RE: GEOTECHNICAL REVIEW OF MACRAES LOM DESIGN 2015

GEOTECHNICAL REVIEW
MACRAES LOM DESIGN 2015

PSM71-194R

OceanaGold Macraes Mine Geotechnical Review of LOM Design 2015 FRIM STAGE 1 SECTION C	
PSM71-194R	Figure 19

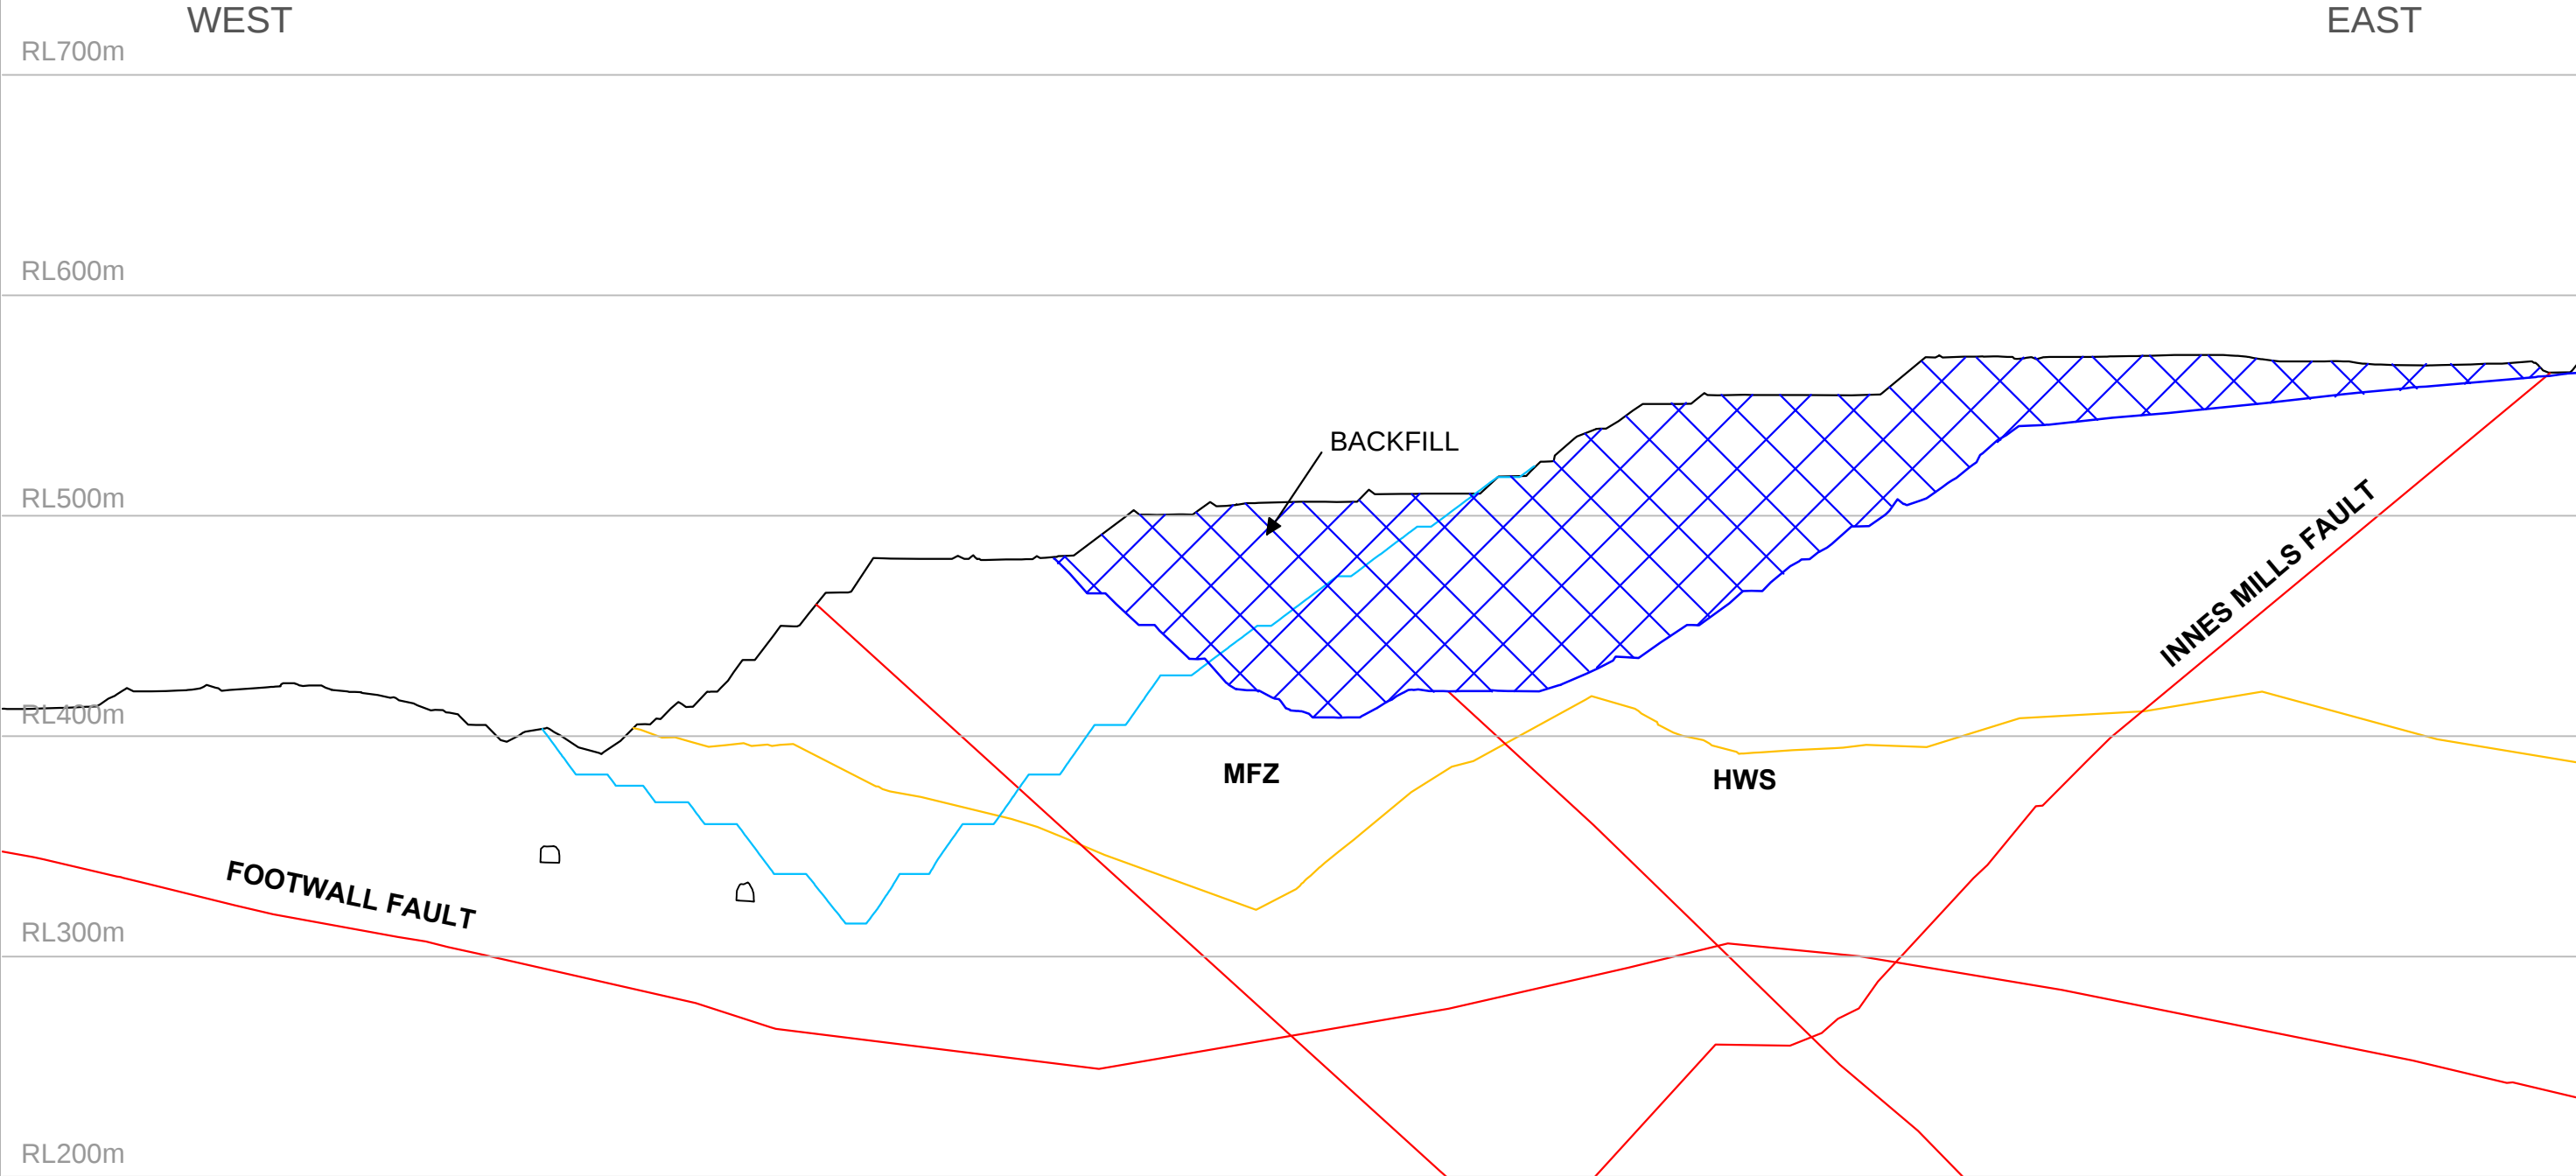
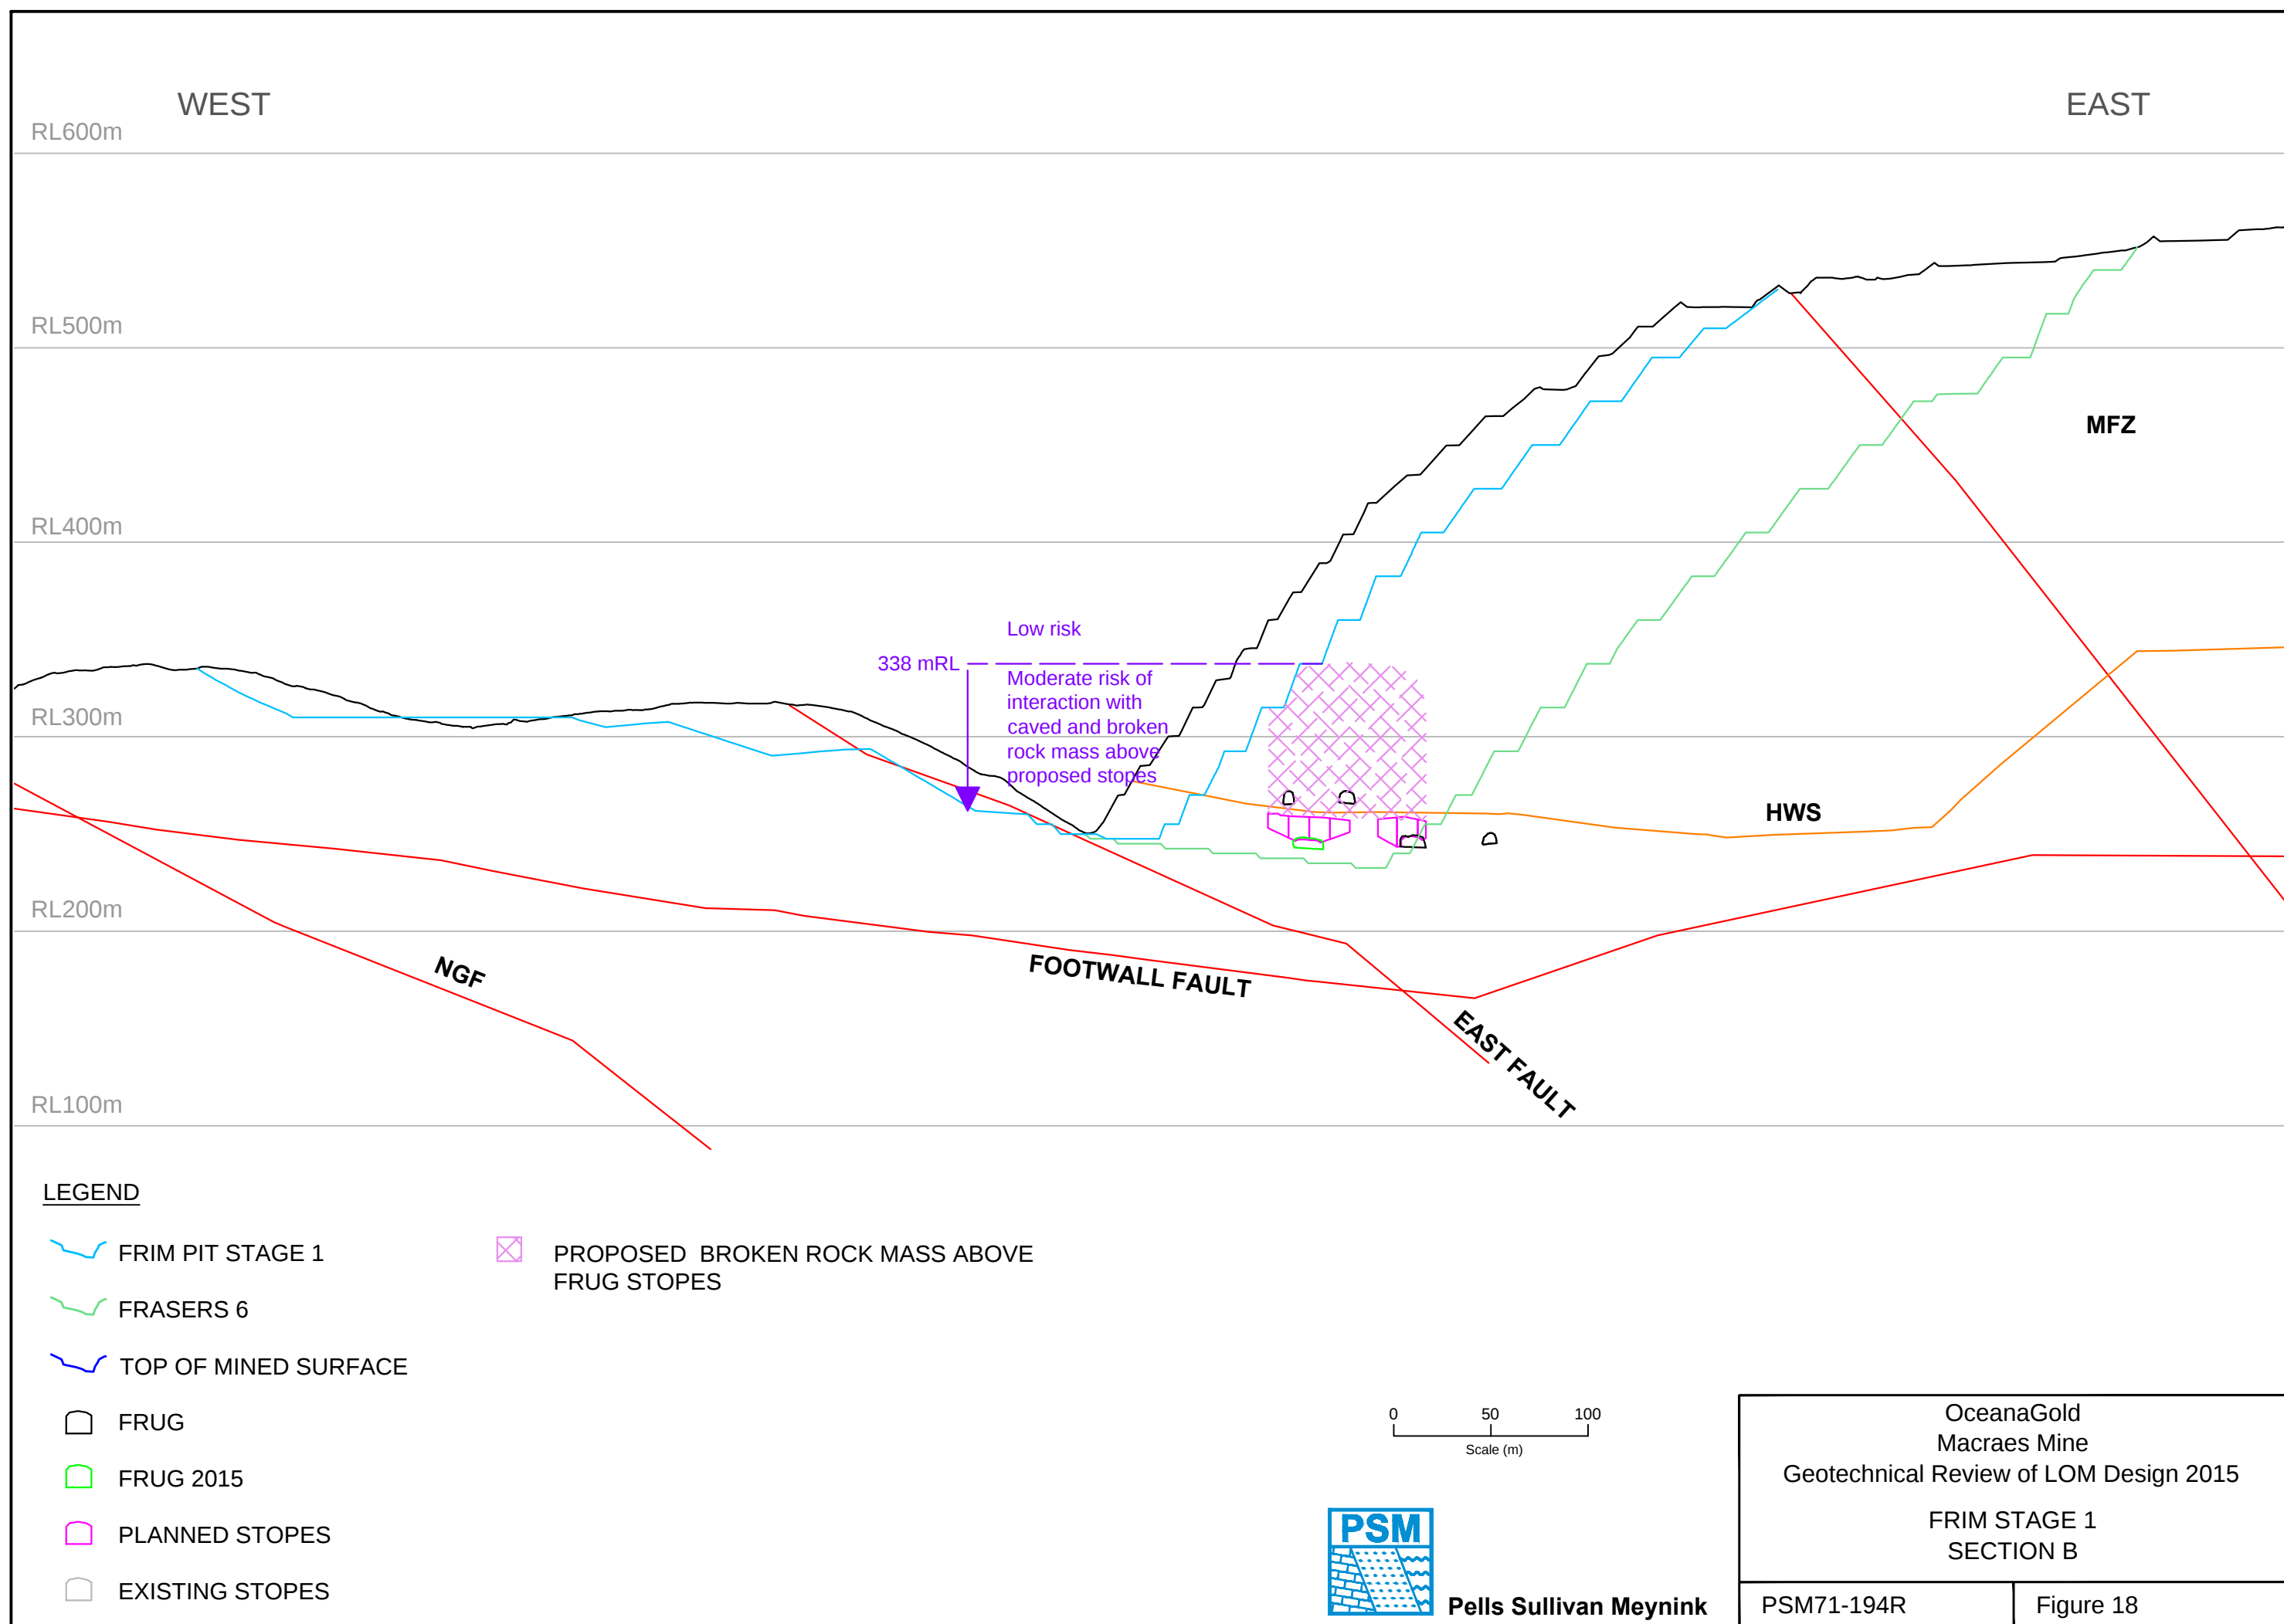
These areas are indicated in Figures 18 to 20.

TIMING OF FRIM STAGE 1	QUALITATIVE RISK
Before FRUG stopes	Low
After FRUG stopes	Moderate

There are no specific recommendations if the FRIM Stage 1 pit is mined before the FRUG stopes. If that is not the case, then OceanaGold will need to develop safe working procedures to mine above voids and broken or caved rock mass. Suggestions regarding probing etc. are provided in Reference 5.
